Reference: Internal Investigation Unit 29 and Chimney, Northface Condominiums, North Conway, NH

Northface Condominiums  
Building 3 East Chimney &  
Unit 29 Thimble  
Internal Investigation Findings

Cross Section View of Unit 29 Thimble

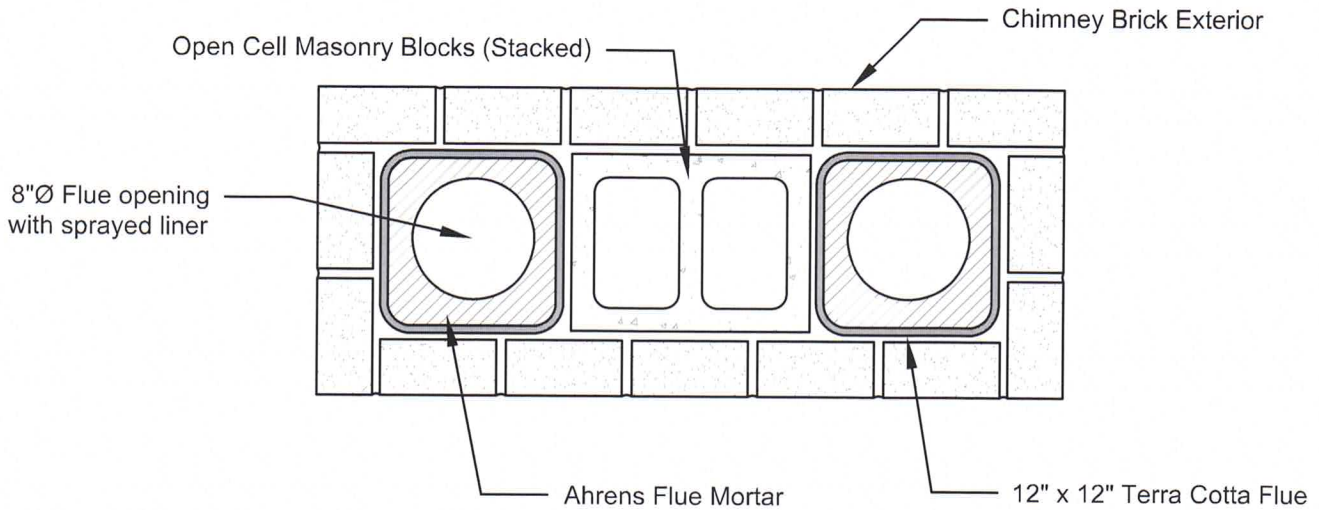
somewhat square brick frame and the round thimble was filled with mortar. The dimension of the area filled with mortar was approximately 12" high by 12" wide, inside the brick "walls" which were found to be on the top, bottom, and sides. In the case of Unit #29, the thimble was found to be a double-wall "metalbestos" (trade name for insulated double wall stainless steel chimney pipe) insulated vent connector. The minimum clearance to combustibles for this type of connector is not specified within the codes but instead is always based on the manufacturer's specific details or "listing," which in this case we do not have as we do not know the manufacturer of the specific product that had been used. Usually however, similar materials are listed to be installed no closer than 6" to combustible materials.

A section of the protective masonry behind the stove was removed which allowed access to and observation of the otherwise concealed area behind the brick. We were comforted to see that gypsum wallboard had been applied to the face of the wall framing and after removing a small section of gypsum, we were comforted to find insulation to have been installed between the studs. We observed and noted that the studs visually were in good condition despite that the area that we viewed was quite close to where the chimney connector would be located, immediately adjacent to the thimble. Visually, no area of the wood studs that were viewed appeared to have experienced pyrolysis, were

As explained above, in the area behind the brick surround that was viewed, we found that gypsum wall board had been installed over the wood stud-wall framing behind the surrounds. Fiberglass insulation was found to have been installed between the studs in the wall cavity of the wall that separates Unit #29 from its neighbor. At the exterior wall however, the wall between the unit and the chimney, the insulation did not fill the stud bay entirely and was absent along the left side of the cavity, adjacent to the thimble. There was a small airspace observed between the back of the brick of the wall surround and the face of the gypsum wall board, this airspace varying between 1/2" to 3/4" in depth. Furthermore, we observed that the airspace was not continuous behind the brick surround as in many areas the mortar between the bricks of the surround had been pushed back into the airspace. Additionally, the airspace was not vented in any manner as it is fully enclosed at the top, bottom and both sides. One inch (1") minimum air space is required between the back of the brick masonry and the face of the wall behind the brick and, the bottom and top courses of brick are to be placed in a staggered configuration which allows free air movement into the area (at the bottom) behind the brick and then outward at the top. This free air movement is what prevents the development of elevated temperatures behind the brick masonry.

Plan View of Chimney with Cap Removed

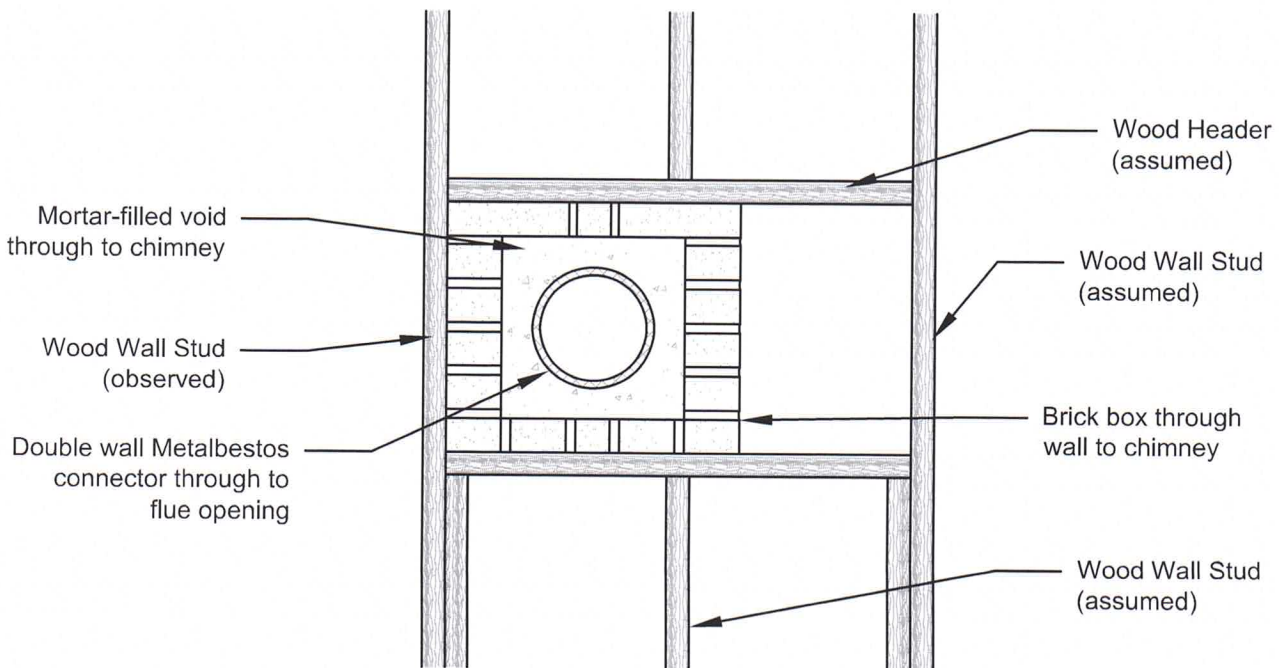
Within each chimney there are two 12" x 12" (outside dimension) 11" x 11" (inside dimension) terracotta flues. Each flue is placed towards the outer edges of the chimney with the space in between the two flues being taken up by a block masonry divider. In the case of the chimney that was opened, each of the flues had been lined with a liner system locally known as the Ahren's method. The perimeter of the interior of each flue has been filled with a proprietary mortar which is installed after sliding an 8" cylindrical form down the chimney. Using this Ahren's method, after the mortar sets up (hardens) around the form, the cylindrical form is removed, leaving behind a round, 8" flue inside what had been an 11" square. Please know that we don't believe each flue in every Northface chimney has had this lining but, for those that have been lined using this method, please know that a round flue is more efficient than a rectangular or square one, but the available flue area has been reduced and this mortar "liner" cannot be removed without destroying the original terracotta flue. IF the two existing flues and the masonry block divider could successfully be removed, we do not believe it possible to properly install six individual flues of appropriate size to serve six solid fuel burning appliances.

**Answer:** No. We have done a lot of research and remain unaware of any flue material that can both fit into the available space and be installed according to either the requirements of the codes or the listing for the material itself. There are several relining materials available, including flexible stainless steel relining materials, DuraFlex being one, however these are "relining" products, listed to be installed to reline an otherwise deteriorated or damaged flue. These are a metallic product that would be used

**Option 2:** The chimneys could be removed entirely from top to bottom. Then, each unit could be provided an appropriately sized Class-A insulated metal vent. The lowermost and middle floor units would definitely be vented up the outside of the building, in the area where the present chimneys are located. Perhaps the third-floor unit's vent could also fit into this same space on the exterior of the building or, the third floor could vent straight up from inside the unit, through the attic/truss area and roof to outdoors. Ideally, all six units' vents would fit into the same space where the present chimneys are. Then, the Class-A vents could be "boxed in" inside a wooden "chimney enclosure" much like many other condominiums in the north country. This is definitely accomplishable and can be fully code compliant.
